FINAL - Q+A QUESTIONS + ANSWERS – Questions submitted through September 30, 2022

Q+A QUESTIONS + ANSWERS – Questions submitted through September 23, 2022

(PRIOR) Q+A QUESTIONS + ANSWERS – Questions submitted through September 16, 2022

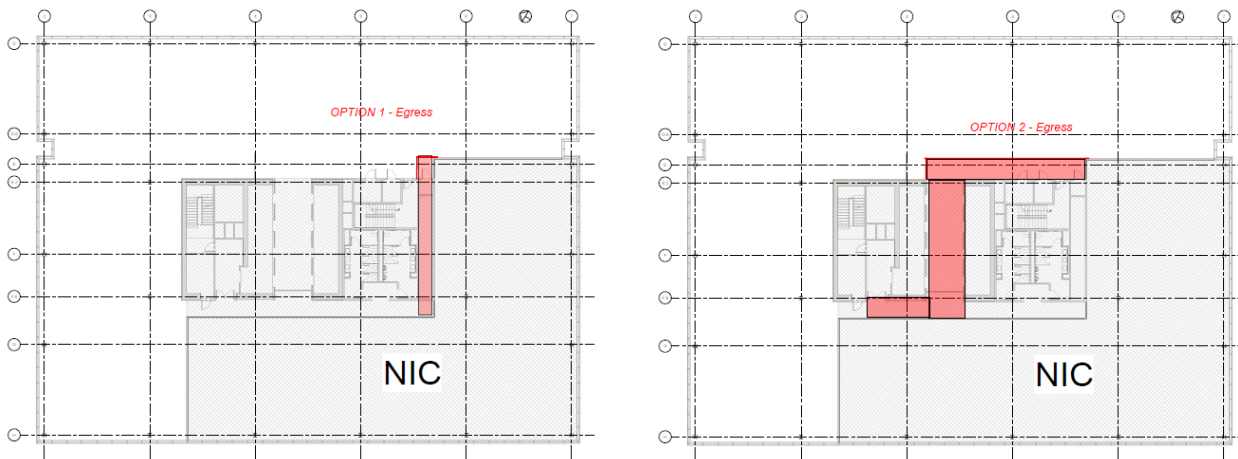
Q: See attached egress option PDF, would you like students to use the Z corridor to provide 2 means of egress (Option 2) or Option 1 with removal of building closets?

A: per earlier responses to similar questions regarding egress in the NIC areas, your students are free to use either option they choose if this helps them design the space. We do not want to be an inhibitor to their design thinking or creativity and though this area is considered NIC; they can make any alterations as necessary to support their design as well as providing a teaching opportunity for faculty.

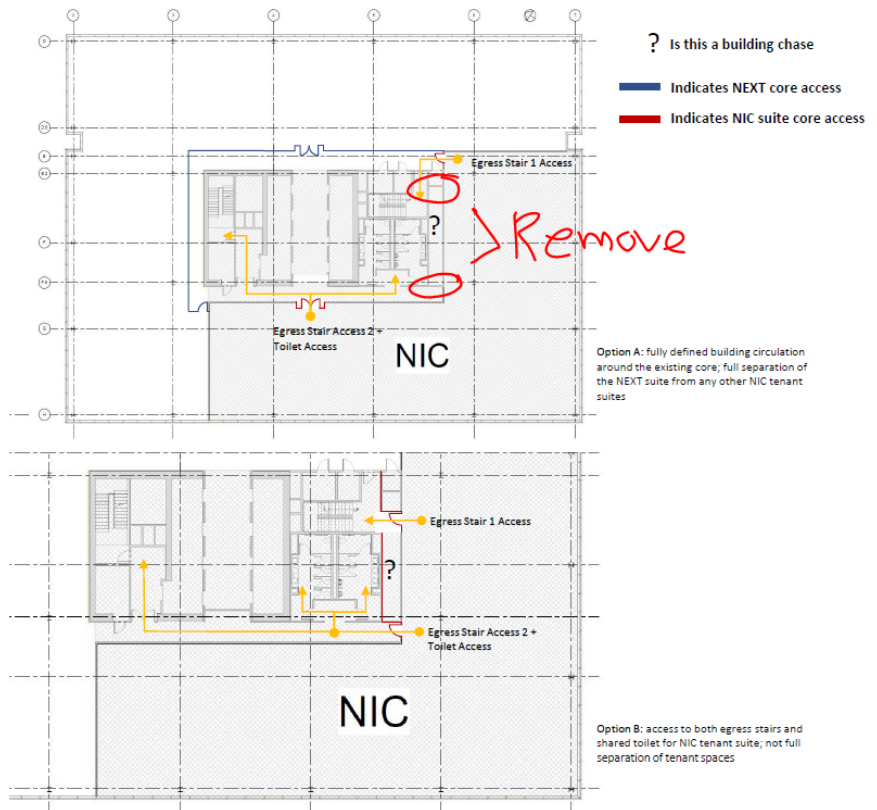
Q: Although the final question/answer directed students to "...consider that everything in the NIC area (including stairs) meets all egress and code requirements" there is still concern among our students about a few key items related to core and circulation.

- 1) In the current configuration there is no separation of suite access from the NEXT space and the NIC tenant suite. This is particularly acute if the elevator lobby is indeed the main access to the 6th floor (as specified in the 9/16/2022 Q+A).
- 2) In the current configuration there is no access to shared toilet rooms or both egress stairs for the NIC tenant space.
- 3) In the current NIC tenant suite zone there is an enclosed area that reads as either a narrow corridor or a building chase (designated to the right with the large ? mark). If it is some sort of hallway (or tenant general space) then it would be able to be utilized for basic egress access (per Option B). Are you able to clarify?

Our students are requesting the option, in particular, to generate a more defined floor circulation around the building core to allow for separation of the suites and to allow access to key elements to the fictitious NIC tenant (option A) OR at the minimum an understanding of how the NIC tenant suite might at least have full access to egress and toilet rooms even if the two suites are not fully separate from one another with regard to elevator lobby access (option B).

We do realize that the NIC does not matter for competition purposes, but ensuring full access to egress and building amenities is a key insight that our students have had about the existing conditions. So, as long as there is not an issue from the competition standpoint, can we give them the freedom to define the core circulation/access a bit more (as loosely shown) in something like option A or option B?

A: We recognize how the undeveloped spaces in the NIC area can cause confusion and/or concern for your students and could also make a challenge for your teaching as an educator. For this purpose, you may remove the two walls I have circled below and that should eliminate any issues of accessibility from the other tenant space. Or, if the students would like to further develop with the options you provided, that is also permitted. Please note, nothing in the NIC area will be considered as part of the judging/evaluation process.

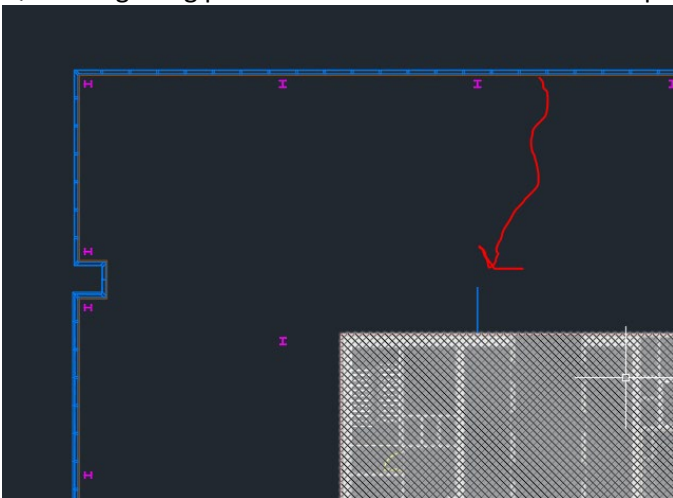
Q: Is the main access to the 6th floor from the elevator lobby. The class was wondering if reception should be in this location.

A: Yes, the main access to the 6th floor is from the elevator lobby.

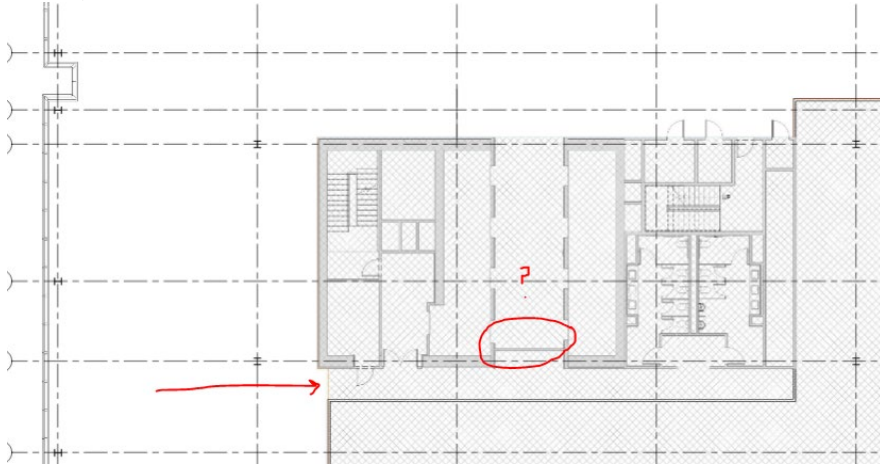
Q: Is the glazing panel attached to elevator wall a misprint? (see image below):

A: This glazing panel is an error that was made by the original modeler of the file that we did not catch. You can remove this from your files.

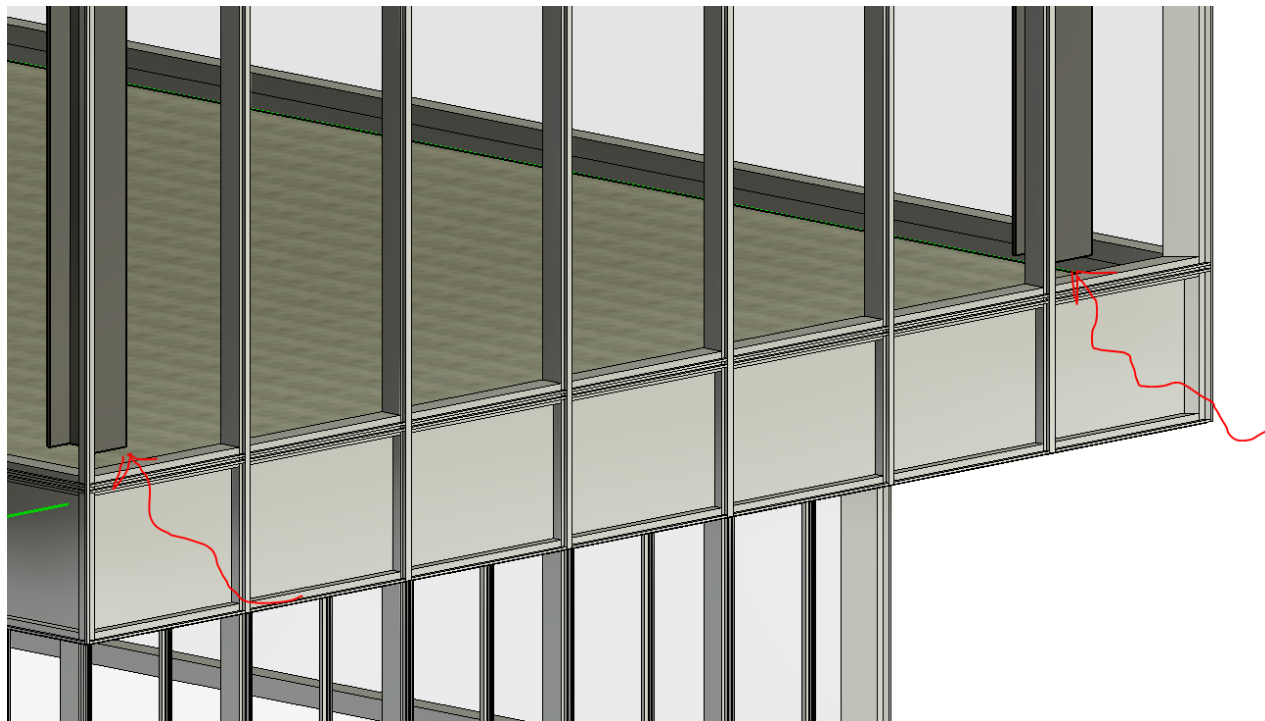
Q: When a person exits the elevator, there is a wall shown that would prevent them from going directly to the bathrooms/bathroom corridor. Is it correct that the only opening to the bathroom corridor is at the plan left (see image below)

A: This is part of the current built condition; however, this is also in the NIC area. You are free to remove this if you wish.

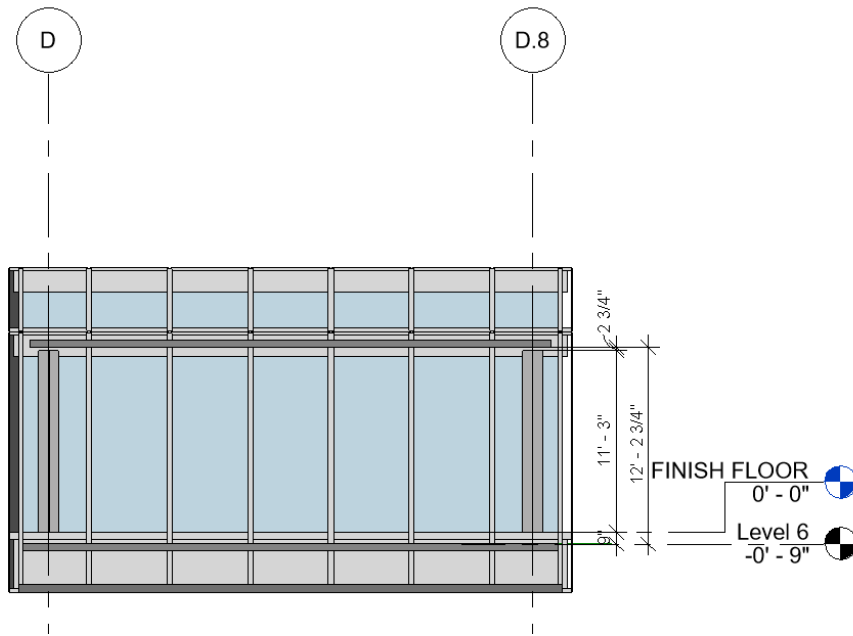
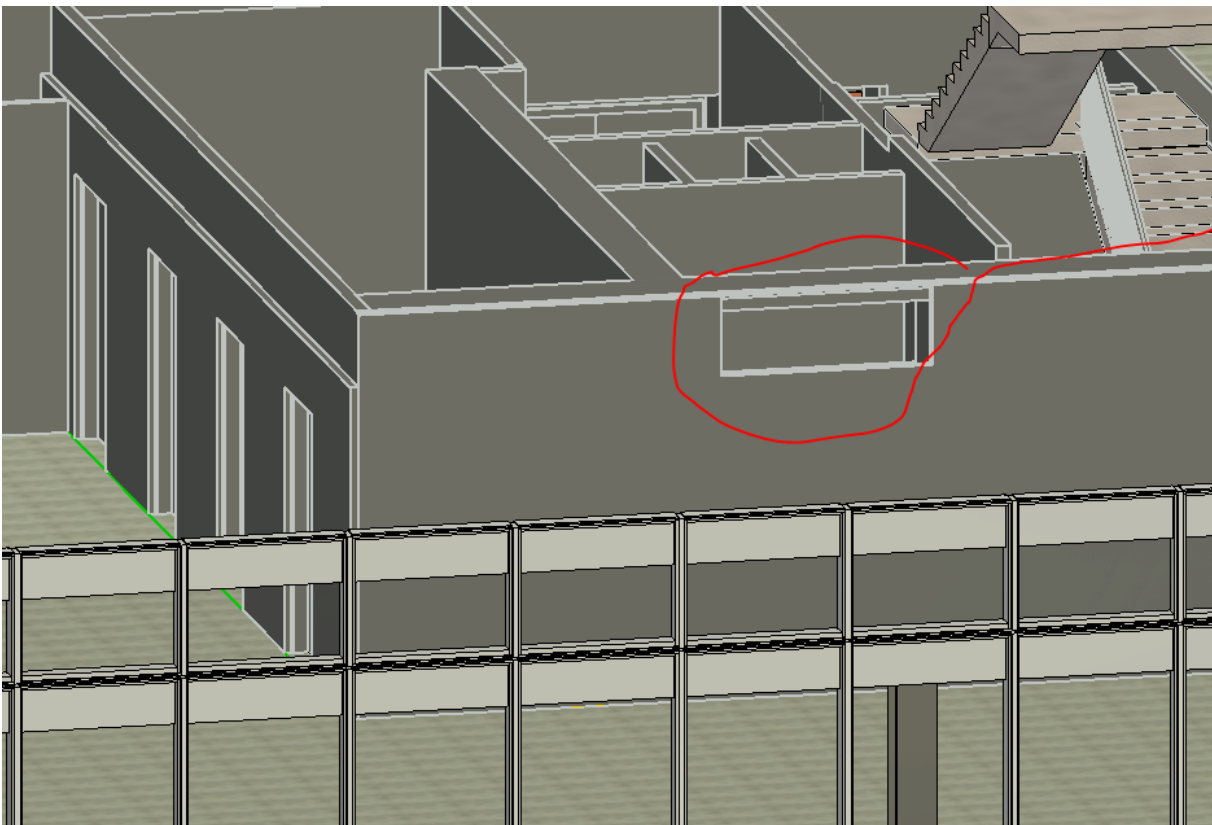
Q: What is the maximum distance from the finished floor to the unfinished ceiling? In the models, there is no actual finished floor so the support columns are floating. (see image below)_

A: When we took the Revit file provided to us by the building owner, we took it back to the base building with no modifications. There was an added raised floor that is causing the issue and apparently there is some condition/treatment at the top that is showing the 2 ¾ space. Therefore, we have provided this elevation that shows

the dimensions. Please use the 12'-2 3/4" dimension as your slab to slab dimension for the competition. Please see below:

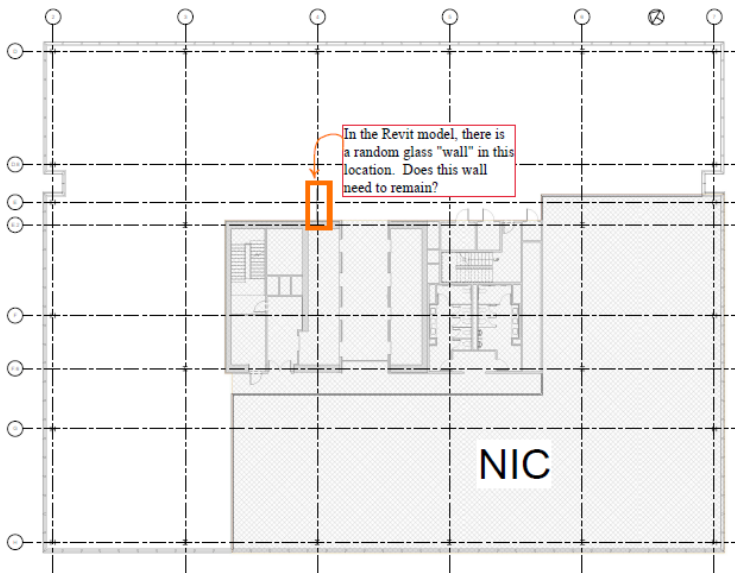
Q: Can this opening at the upper wall be removed? (see image below):

A: Yes, that would be permitted.

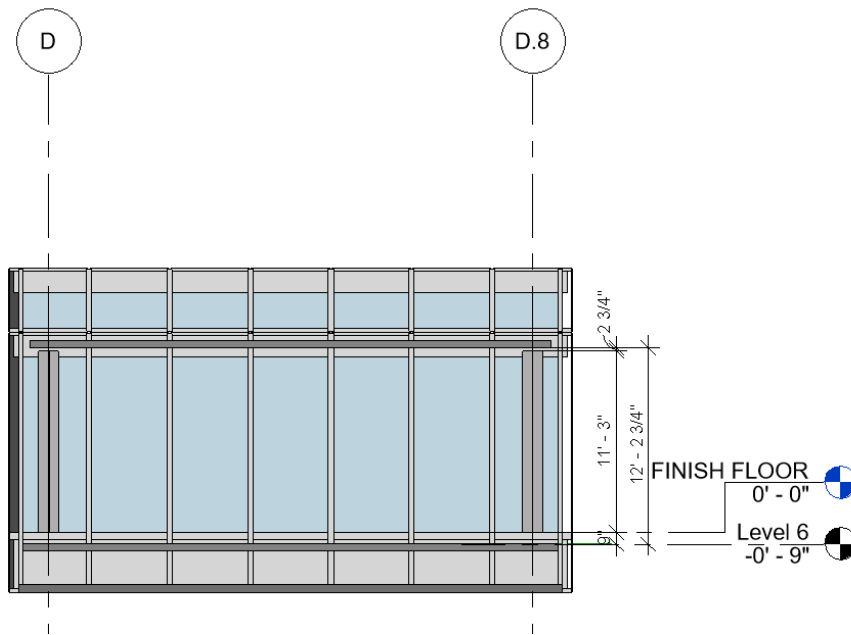
Q: Specification: What specific mechoshades are being provided? What do they do for the design? Are we able to customize the colors of the mechoshades on the exterior windows?

A: Any mechoshade and/or mechanical shade system the student wishes to provide is fine. Any color is acceptable.
